Arboricultural Impact Assessment Addendum

South Wokingham Distributor Road, Wokingham, Berkshire

Project Number: 4977

Arboricultural Impact Assessment Addendum

WMHP-TG-SRWG1-DR-LS-3041

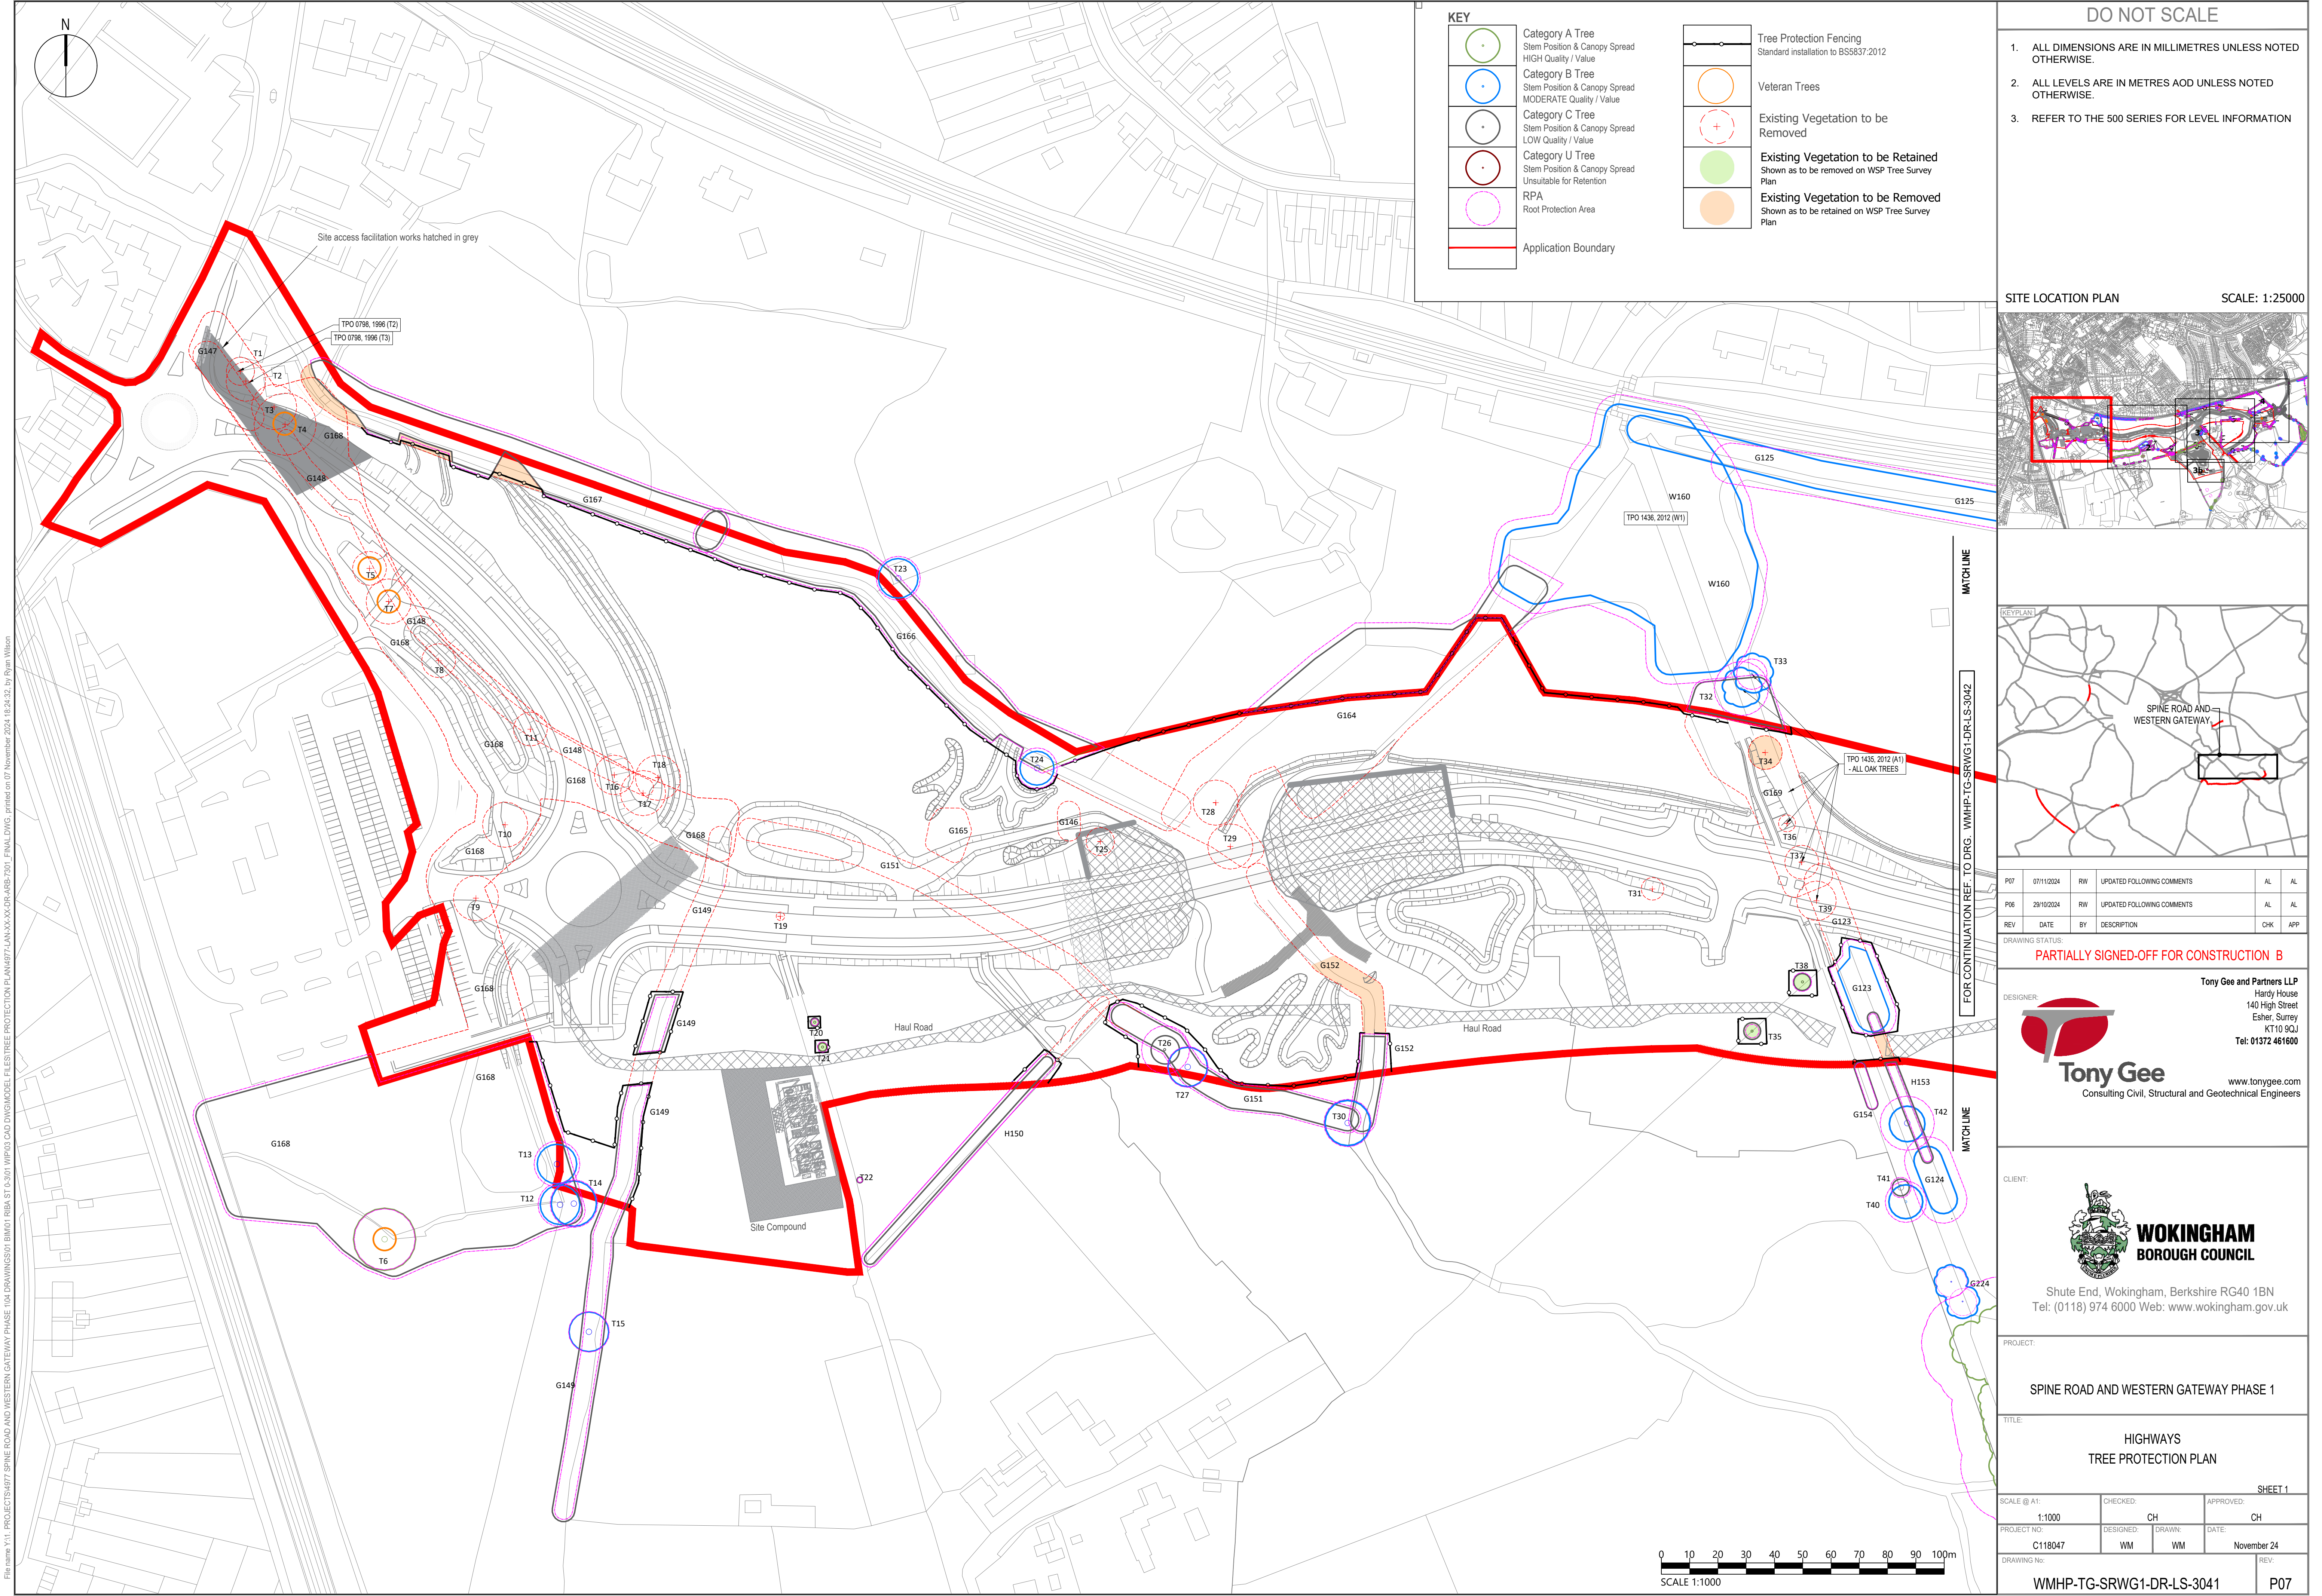
- 3.1.1 This addendum is intended to address the following changes:
- Updates to the Tree Protection Plans and Arboricultural Method Statement produced by Lanpro in 2024¹ to reflect the new proposals with regard to landscaping, road layout, and other pertinent design plans;

- 5.1.1 Table 1 below sets out the arboricultural impacts identified in WSP's original AIA for the Scheme. Tables 2-4 below then sets out the revised arboricultural impacts for the Scheme which correspond to Lanpro's revised Tree Protection Plans and Arboricultural Method Statement.
